**FINAL FINDINGS, CONCLUSIONS AND DECISION OF THE
DESIGN COMMISSION
ON AN
APPEALED ADMINISTRATIVE DECISION
(TYPE II PROCEDURE)**

Case File Number: 22-159396 AD: 2788 NW THURMAN ST

Case Type: AD (Adjustment Review – 2 Concurrent Adjustments)
Procedure: Type II, an administrative decision with appeal to the Adjustment Committee.

Exh. C.2
LU 22-159396 AD

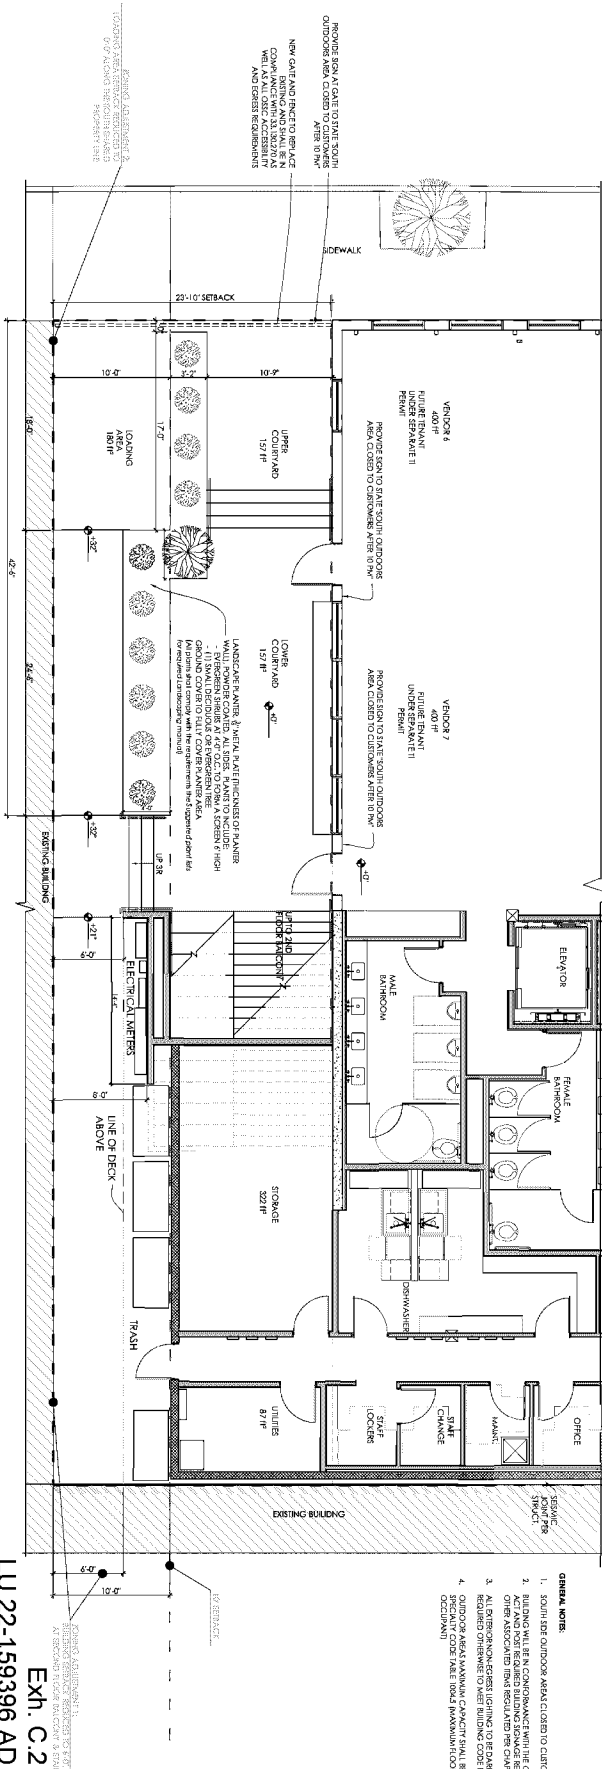
In response to the assertion that approving the Adjustment request will allow a roof patio and seating within the setback, staff notes that the applicant submitted a revised plan set which increased the width of the landscape planter areas along the southernmost seating areas (lower courtyard, stadium seating, and lower rooftop deck) to 4 feet to allow for additional landscape buffer area and to eliminate customer seating areas within the minimum 10-foot building setback for abutting residential lots. (Exhibit C.2).

- B. The landscaped buffer areas along the southern edge of the seating areas (upper courtyard, lower courtyard, stadium seating, and lower rooftop deck, as shown on Exhibit C.2) must be continuously maintained in a healthy manner. Plants that die must be replaced in kind.

Ground Floor Plan

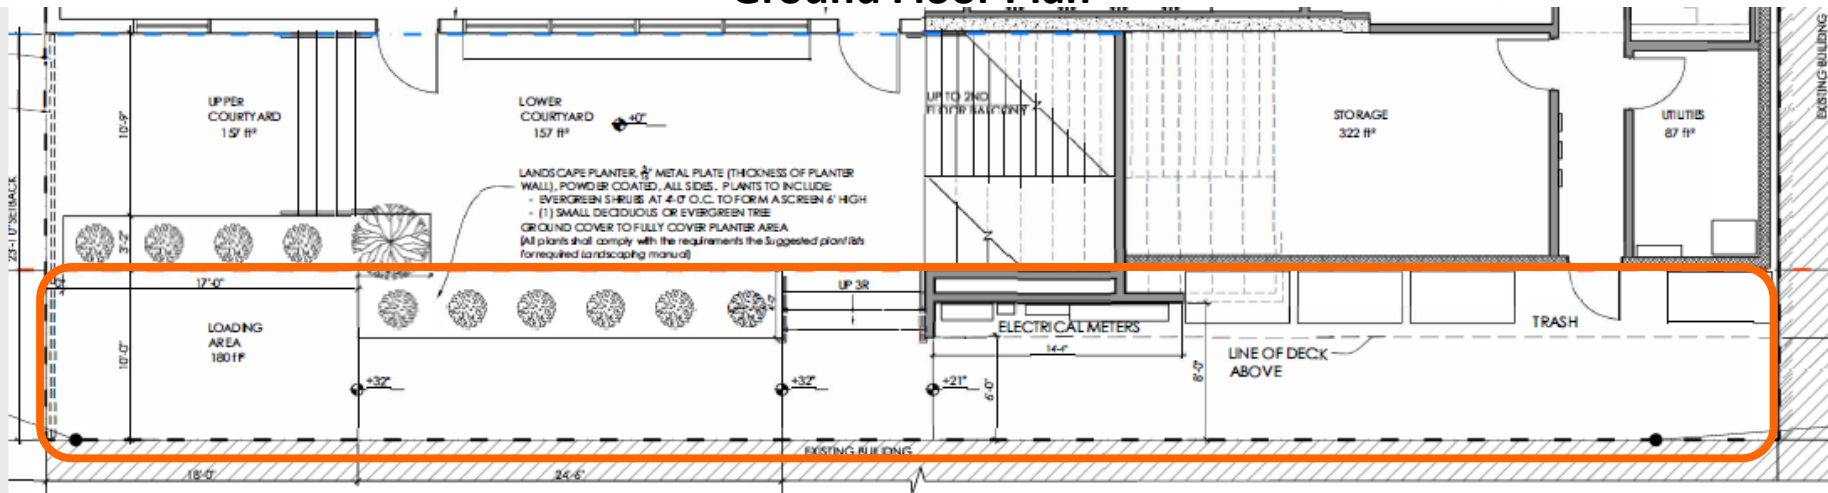
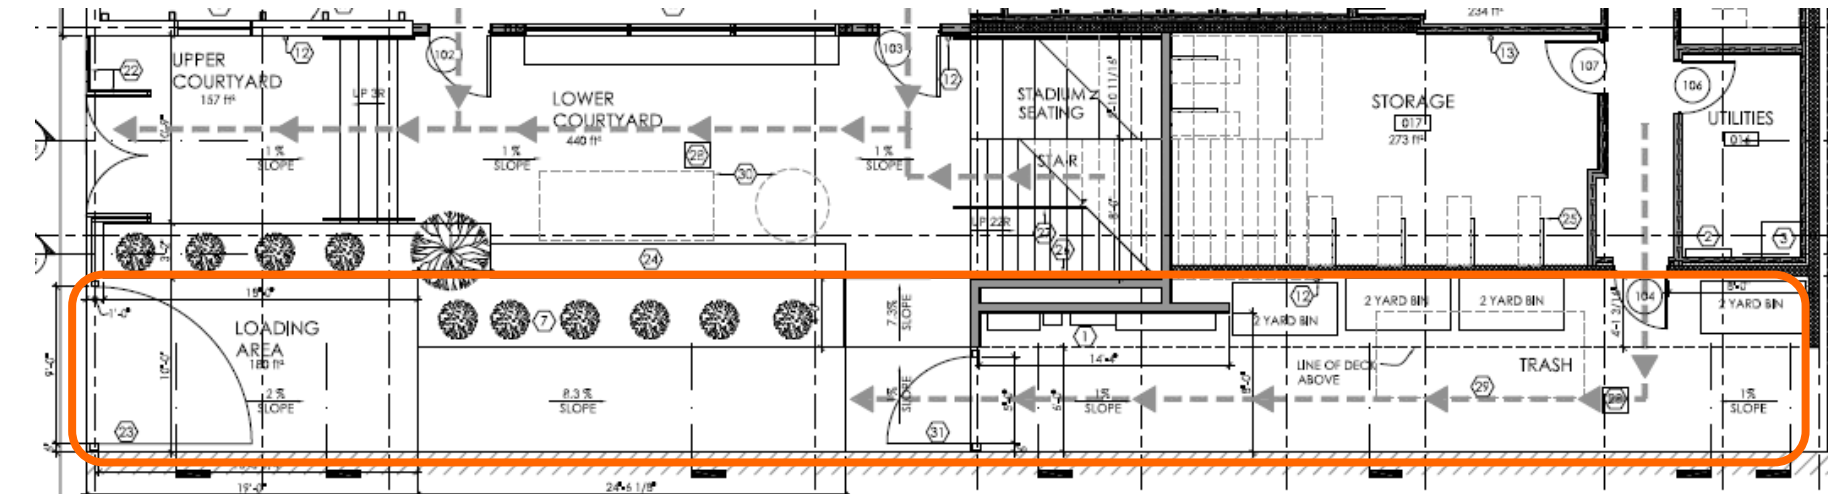
- Exterior stadium seating and stairs between patios are flipped (with stadium seating at the north and the stairway at the south) to provide an uninterrupted landing at the bottom of the staircase;
- More detailed gate and fencing information has been added along the 28th avenue ROW at the west end of the courtyard and loading area;
- A gate/ screen is provided at the west end of the trash and electric meter location to help better enclose this area; and
- Stairs between south courtyard and southernmost access area are removed (slopes as determined by civil are indicated).

Upper Floor Plan

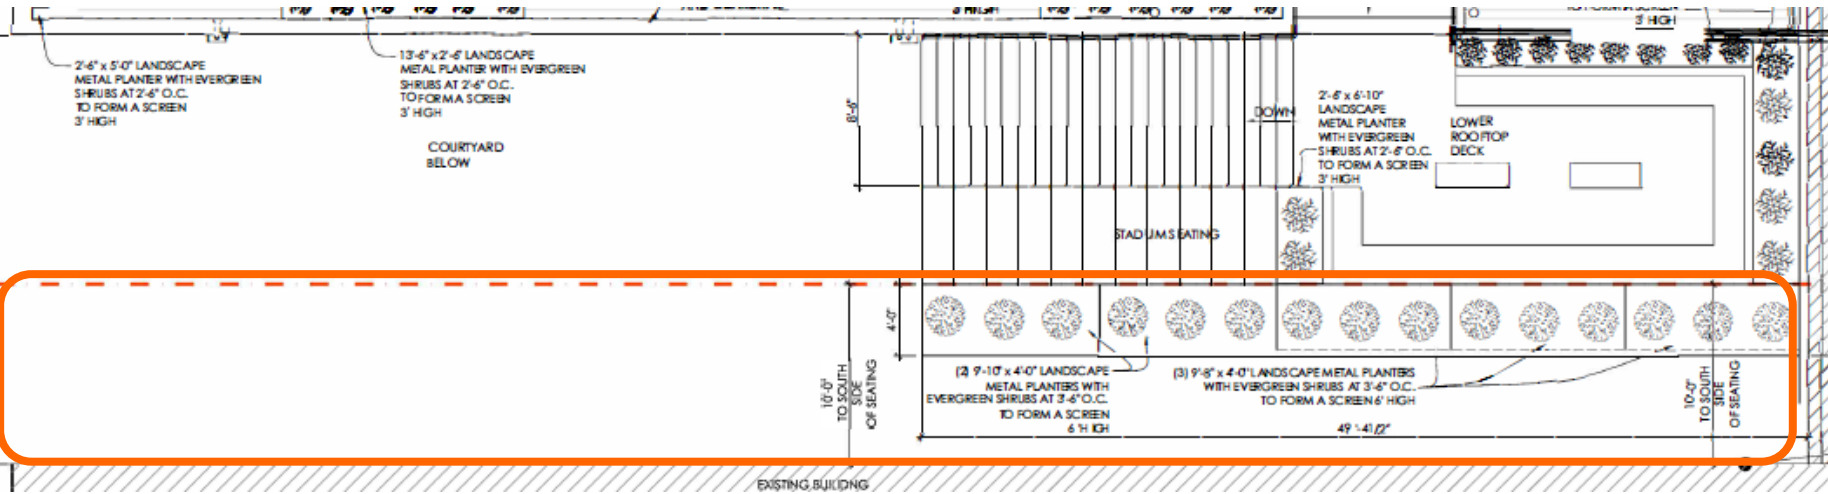
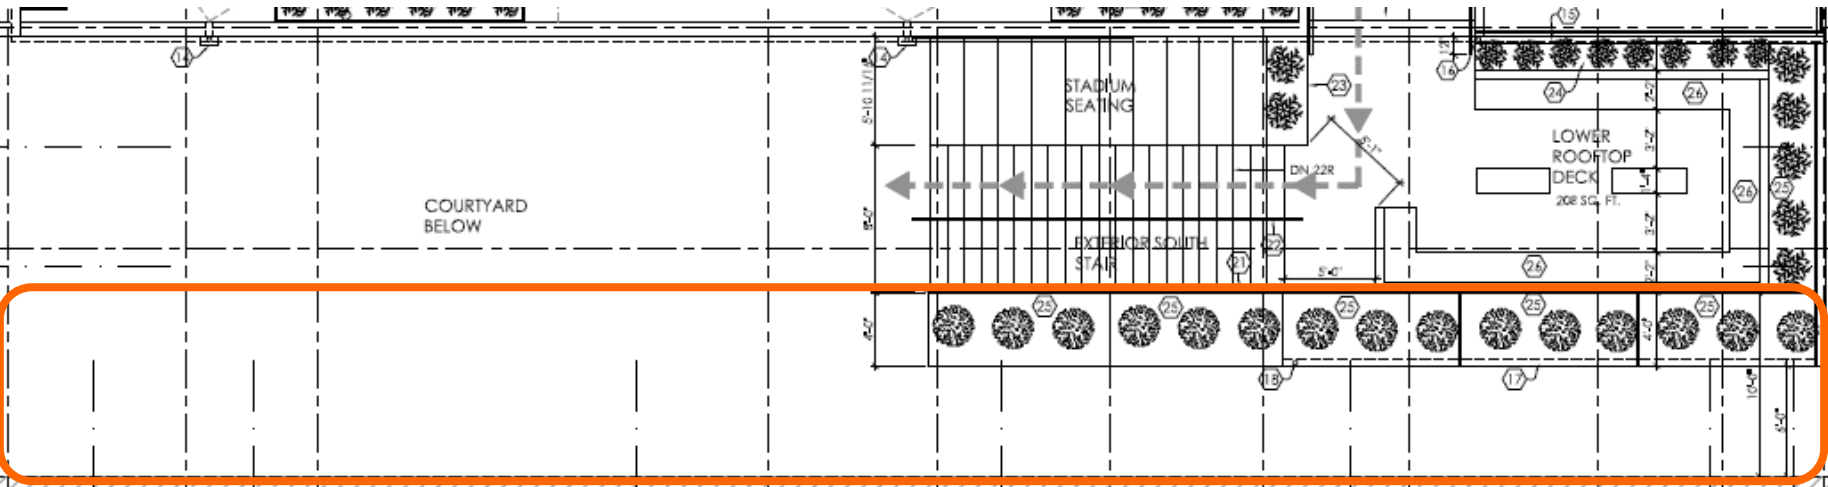
- Exterior stadium seating and stairs between patios are flipped (with stadium seating at the north and the stairway at the south) to provide an uninterrupted landing at the bottom of the staircase;
- More detailed gate and fencing information has been added along the 28th avenue ROW at the west end of the courtyard and loading area;
- A gate/ screen is provided at the west end of the trash and electric meter location to help better enclose this area; and
- Stairs between south courtyard and southernmost access area are removed (slopes as determined by civil are indicated).

East Elevation

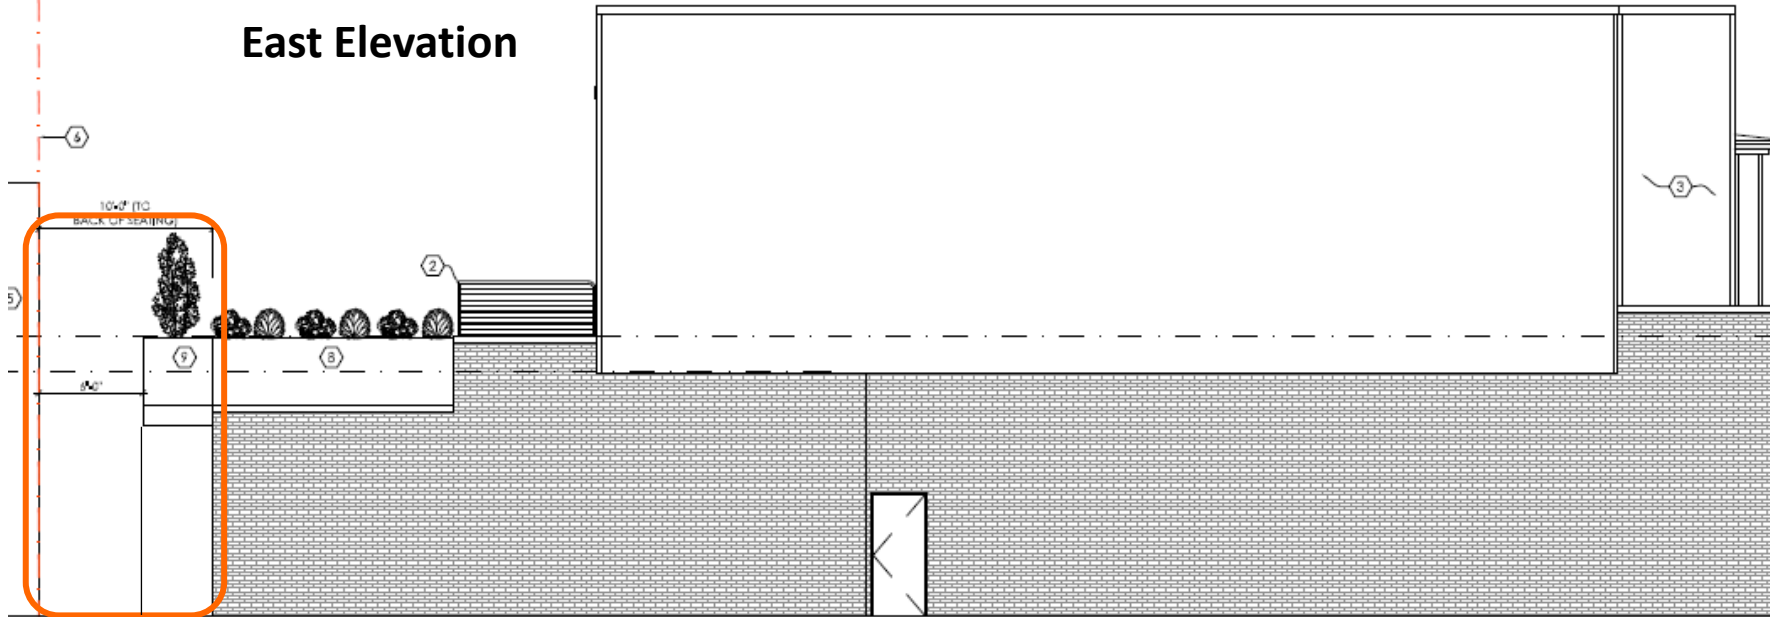
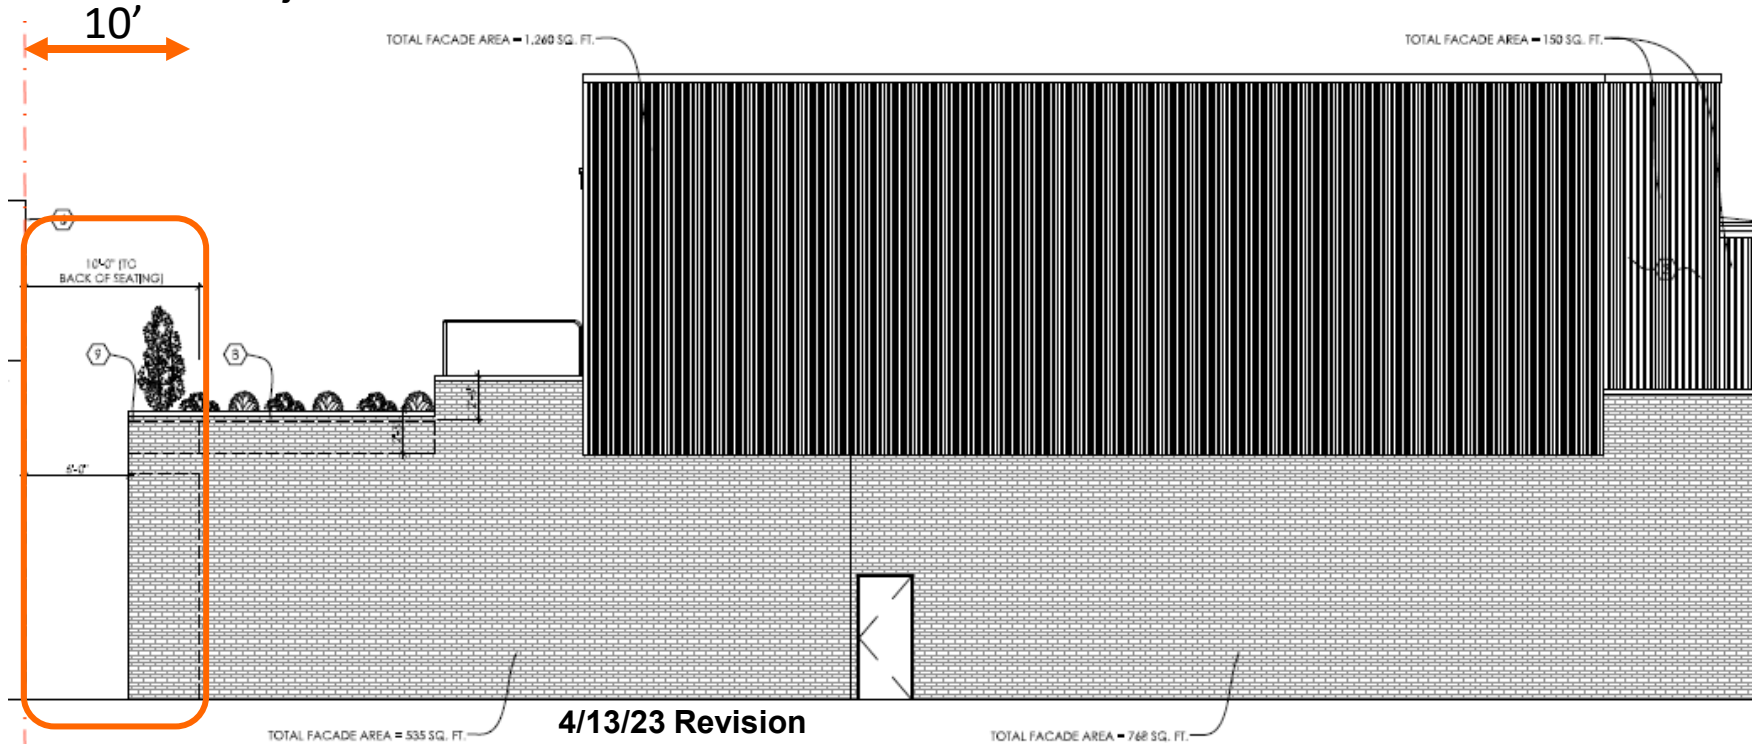
- Exterior stadium seating and stairs between patios are flipped (with stadium seating at the north and the stairway at the south) to provide an uninterrupted landing at the bottom of the staircase;
- More detailed gate and fencing information has been added along the 28th avenue ROW at the west end of the courtyard and loading area;
- A gate/ screen is provided at the west end of the trash and electric meter location to help better enclose this area; and
- Stairs between south courtyard and southernmost access area are removed (slopes as determined by civil are indicated).
